# Tallawarra Lands Traffic Impact Assessment Addendum

February 2012

Date: 29<sup>th</sup> February 2012  
Reference: 4373  
Status: Final 1

This addendum report has been prepared as a result of additional comments provided by Roads and Maritime Services (RMS) and Wollongong City Council (WCC) regarding the contents of the original TIA. Each comment will be addressed individually.

Figure 3.1: Lane Type Comparison

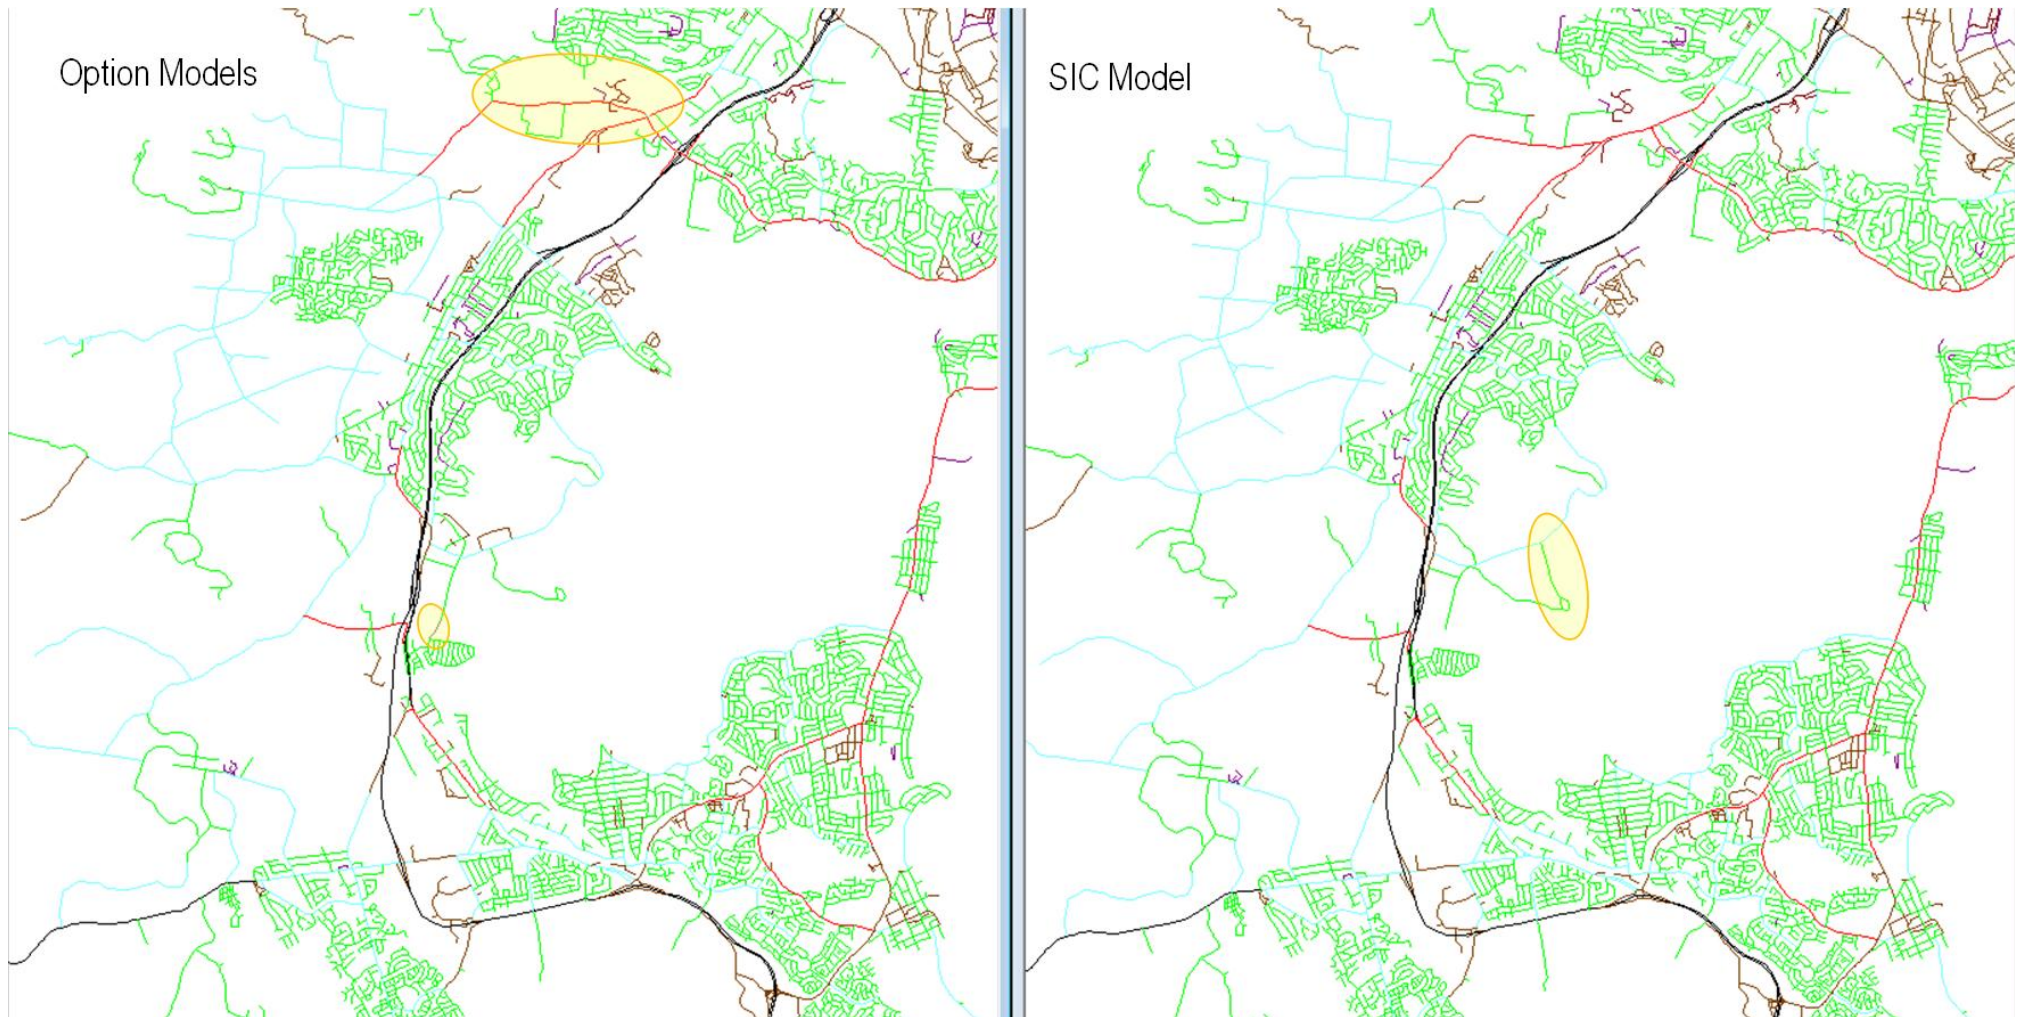
Figure 3.1 to Figure 3.4 show comparisons between the SIC models and the development option models. Figure 3.1 shows that the lane types are generally consistent between the SIC model and development models. Two coding differences were identified and are included below.

**Issue#10:** West Dapto Road is shown as a four lane road from Darkes Road to Northcliffe Drive.

Figure 3.2: Intersection Treatments (south) Comparison

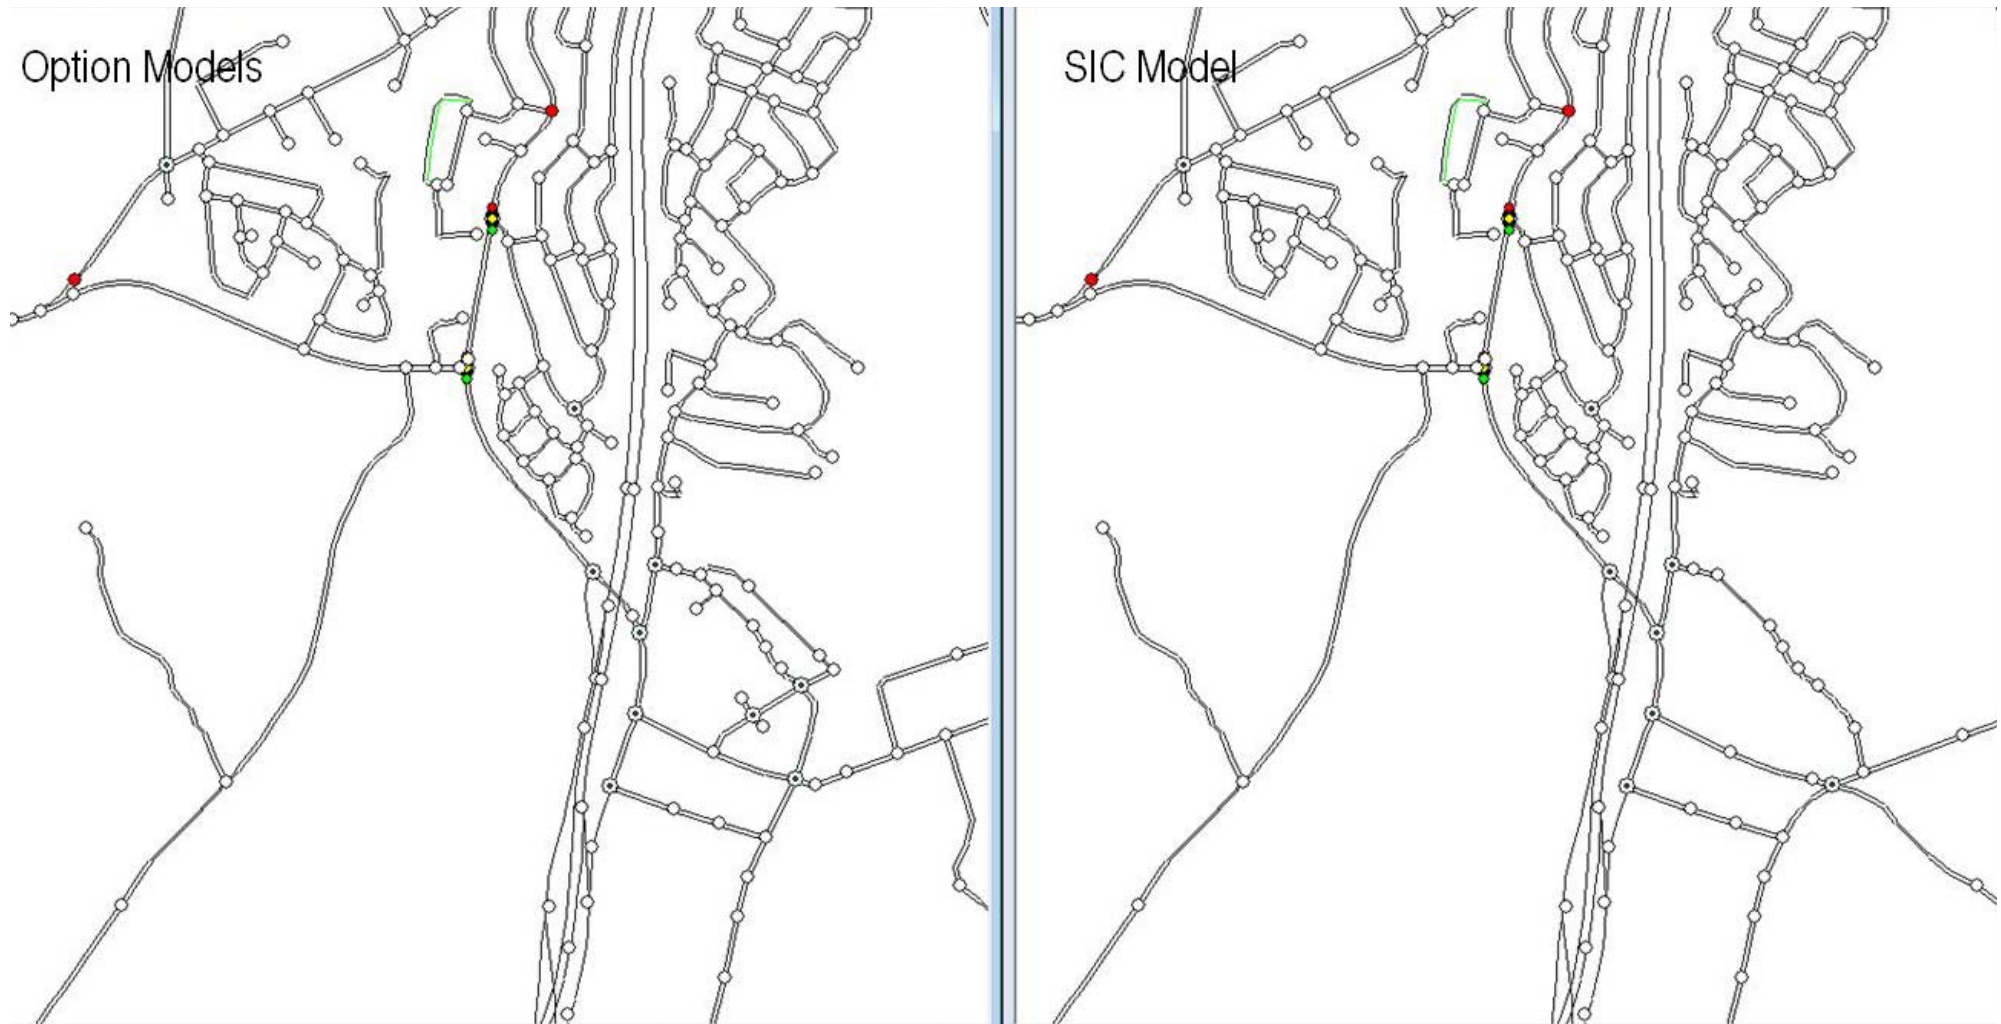
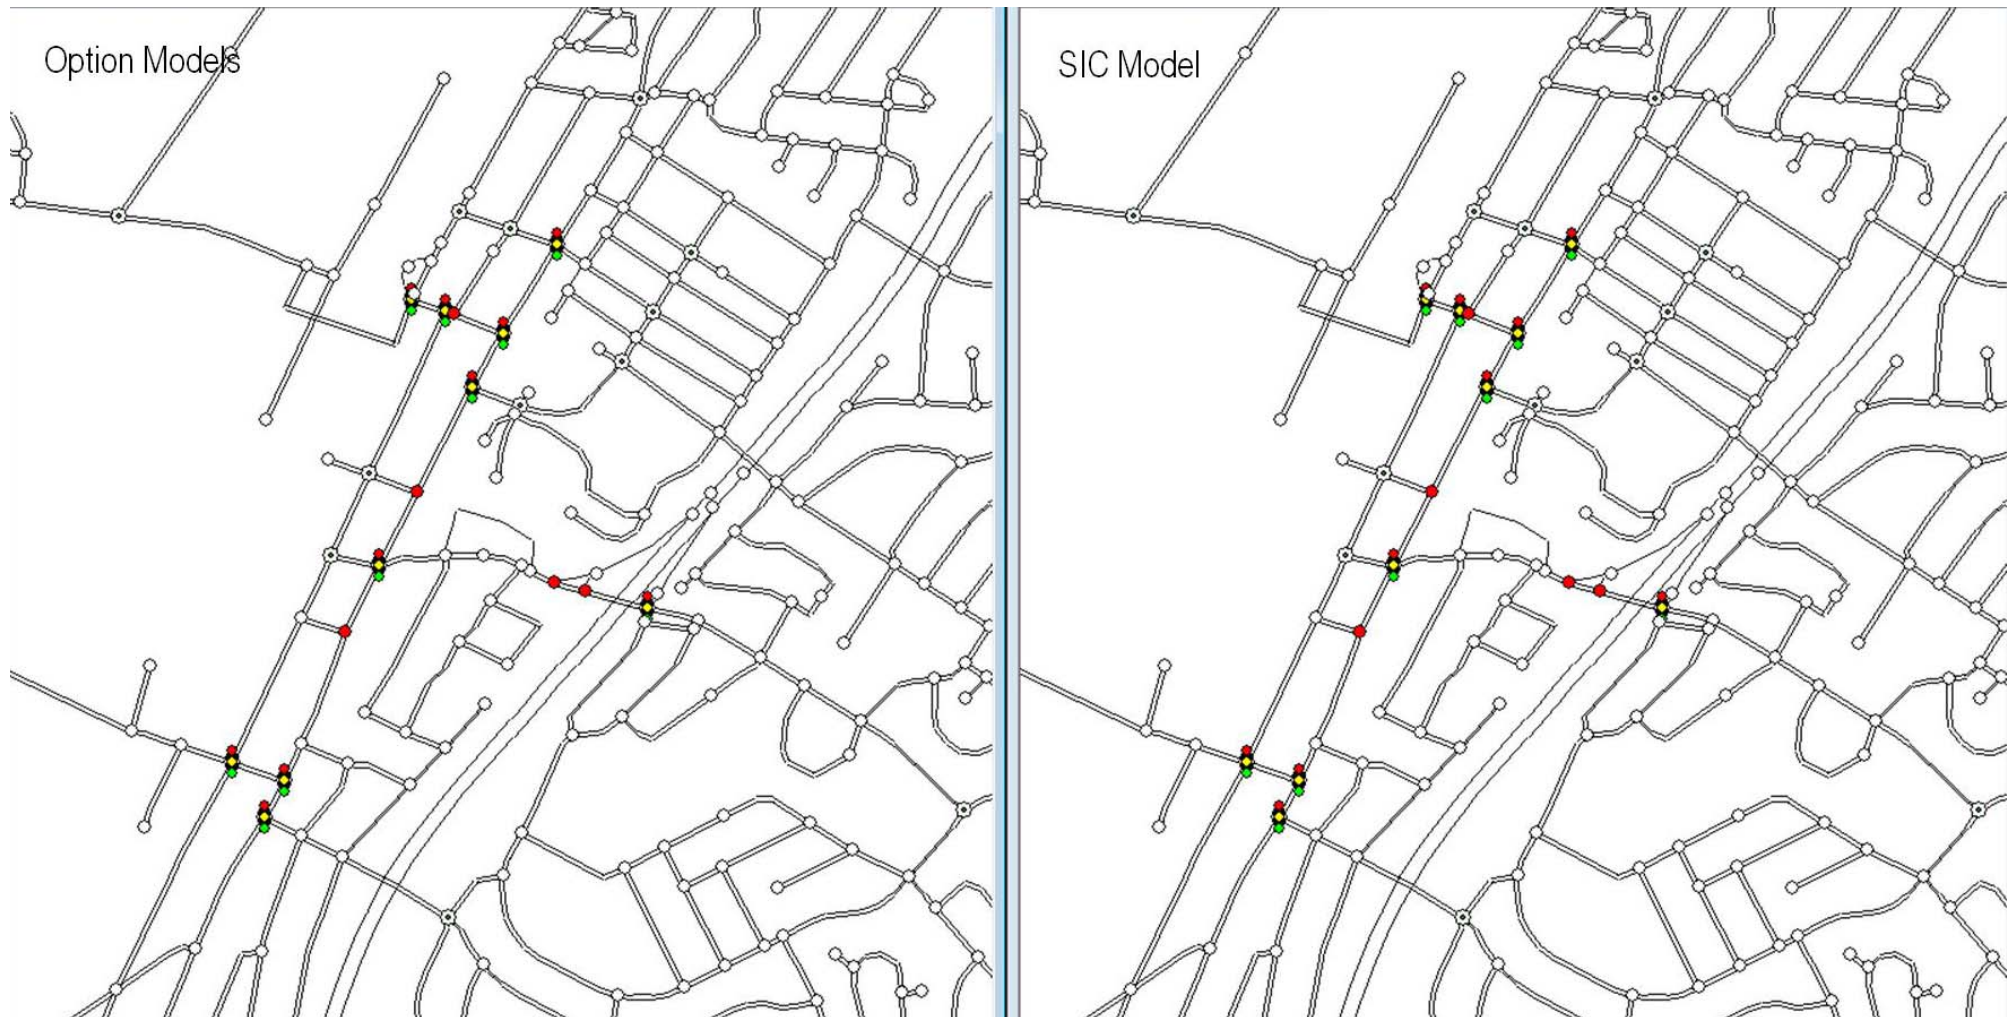
Figure 3.2 and Figure 3.3 shows the comparison of intersection treatments between the SIC model and development models. No discrepancies were identified. It should be noted that the development models include single lane links with two approach lanes on the proposed new roundabouts at Tallawarra interchange which is considered acceptable. A number of signalised intersections along the Princes Highway were also checked with no discrepancies found in the intersections reviewed. Figure 3.4 shows the comparison of the number of lanes between the SIC model and development models with the single issue included below.

Figure 3.5: Existing Bus Services in the Dapto Area

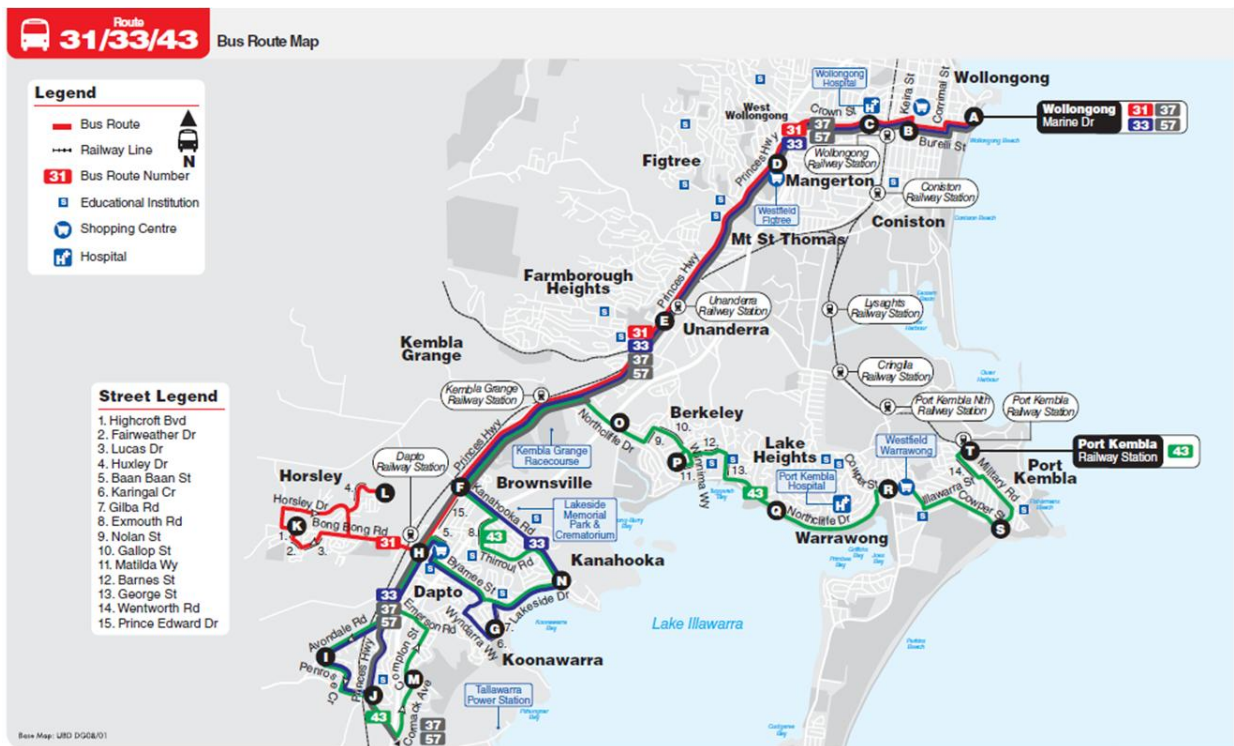
**Issue 17#:** It is unlikely that the proposed bus routes (Figure 30 – TIA) would be feasible as patrons levels would not exceed the critical mass required to make it viable. Re-consideration of the proposed bus route strategy / plan is required unless the services are planned to be heavily subsidised by the developer on an ongoing basis. Figure 3.5 shows the existing bus routes in the area, with Service 43 being the only service that can easily be extended, with consideration maybe given to extending Service 33 via Gilba Road to address the eastern residential area.
